GOVERNMENT STREET HIGHLANDS SUBDIVISION, RESUBDIVISION OF LOT 40

APPLICATION NUMBER 7 DATE June 2, 2016
 APPLICANT Government Street Highlands Subdivision, Resubdivision of Lot 40
 REQUEST Subdivision

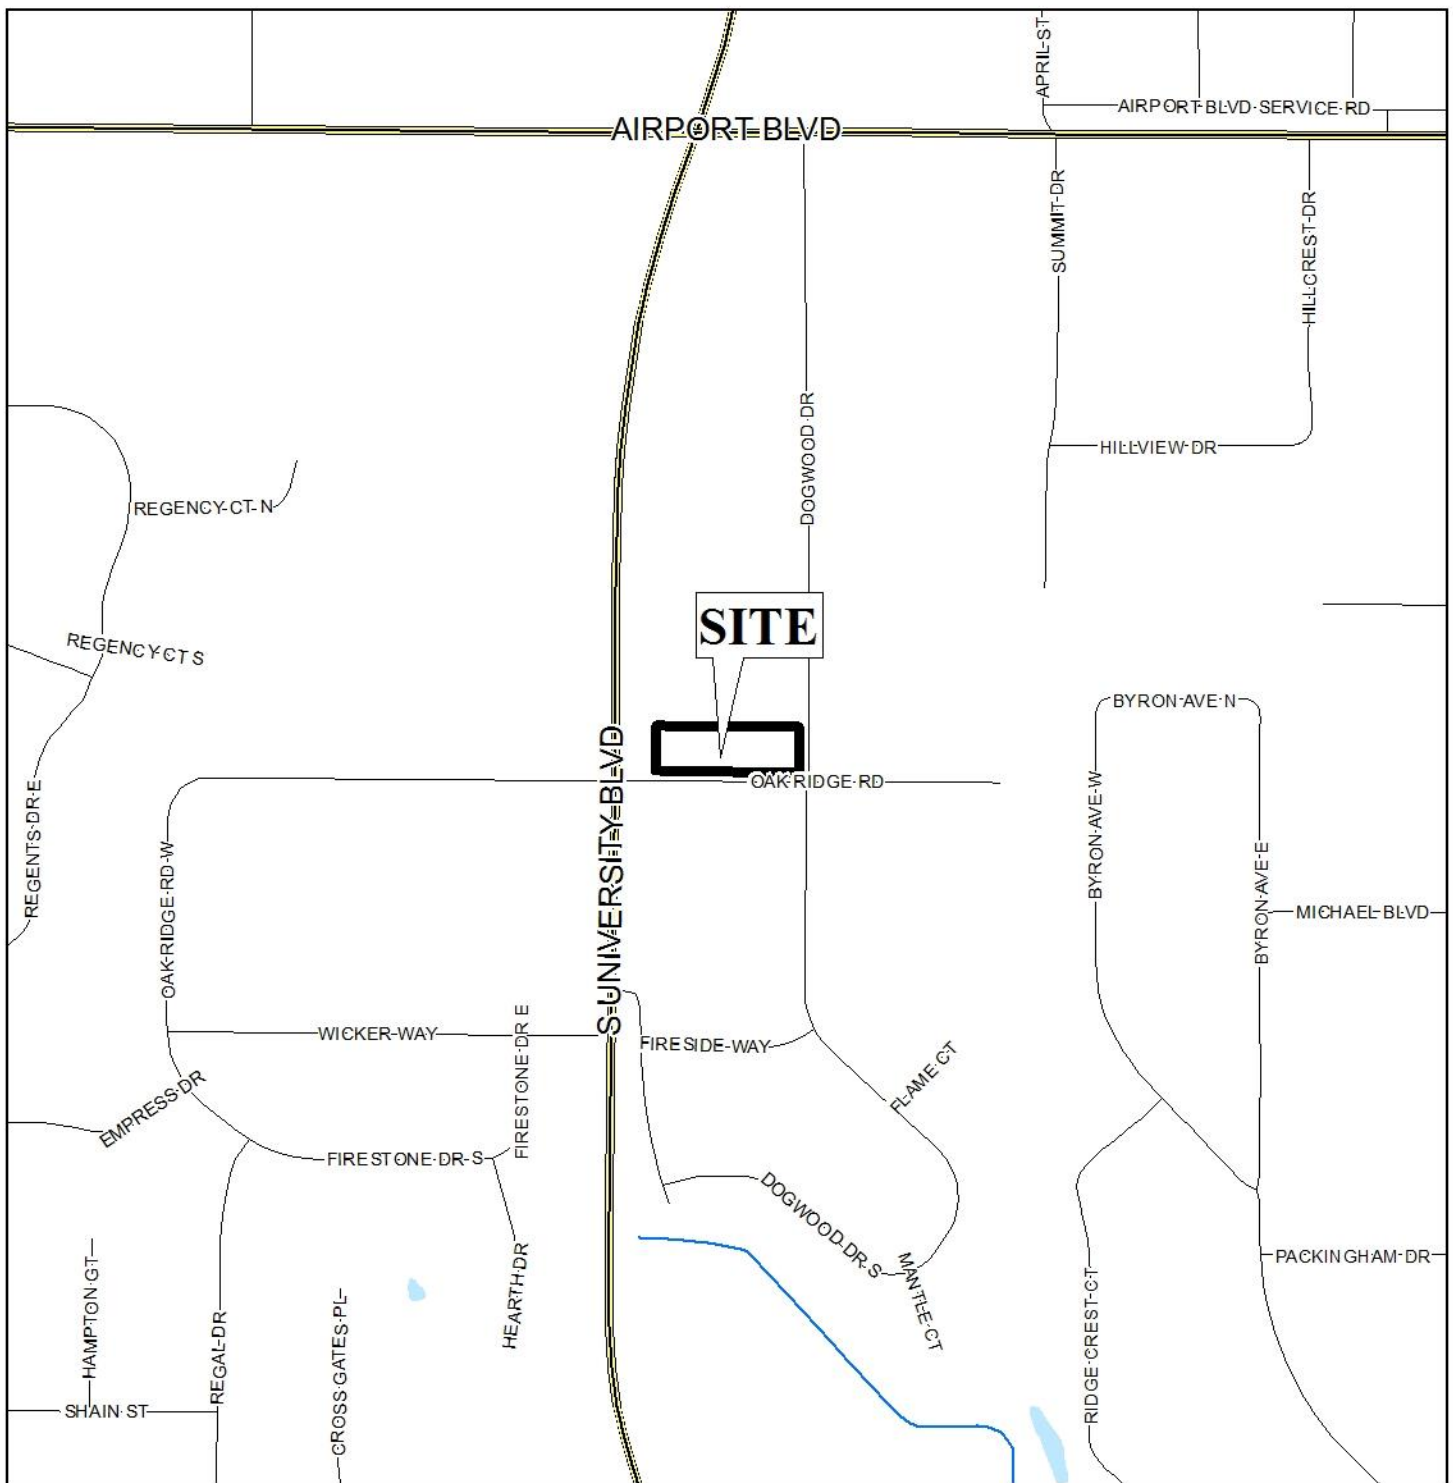
The lot sizes are labeled on the preliminary plat in square feet, and should be placed on the Final Plat in square feet and acres, if approved. It should be noted that the proposed lots would exceed the required lot size minimum in Section V.D.2. of the Subdivision Regulations.

The site has frontage onto Oak Ridge Road and Dogwood Drive, both minor streets with curb and gutter, and are illustrated as having 50' and 60' wide right-of-ways, making no dedications necessary. However, dedication of the corner radii at Oak Ridge Road and Dogwood Drive per Section V.D.6. of the Subdivision Regulations should be required, as illustrated on the preliminary plat.

As a means of access management, a note should be required on the Final Plat, if approved, stating that each lot is limited to one curb cut, with the size, location and design to be approved by Traffic Engineering and conform to AASHTO standards.

The preliminary plat depicts a 25-foot minimum building setback line along Oak Ridge Road, and a 20-foot minimum building setback line along Dogwood Drive. Section 64-4.D.3. of the Zoning Ordinance allows a corner lot to have a side-yard setback of 20-feet, therefore a waiver of Section V.D.9. of the Subdivision Regulations may be appropriate. The setback line should be illustrated on the Final Plat, as on the preliminary plat.

There is a 7.5' drainage and utility easement along the rear of the proposed lots, as well as a 5' Alabama Power Company & AT&T easement along all frontages. A note should be placed on the Final Plat stating no structures are to be erected in any easement.

It should be noted that there is an existing dwelling on the proposed Lot 4. While the existing dwelling is not illustrated on the preliminary plat, it does not appear that the approval of this subdivision will create a zoning violation, and that the existing structure will meet all setbacks.

Based upon the preceding, the application is recommended for Tentative Approval, with a waiver of Section V.D.9. of the Subdivision Regulations for the Dogwood Drive side of the Lot 5, subject to the following conditions:

- 1) retention of the dedication of the corner radii at Oak Ridge Road and Dogwood Drive per Section V.D.6. of the Subdivision Regulations;
- 2) placement of the lot size in square feet and acres;

- 3) placement of a note stating each lot is limited to one curb-cut with the size, location and design of all curb cuts to be approved by Traffic Engineering and conform to AASHTO standards;

- 4) depiction of the 25-minimum building setback along Oak Ridge Road;
- 5) depiction of the 20-foot setback along Dogwood Drive;
- 6) compliance with Engineering comments (*The following comments should be addressed prior to submitting the FINAL PLAT for acceptance and signature by the City Engineer:*
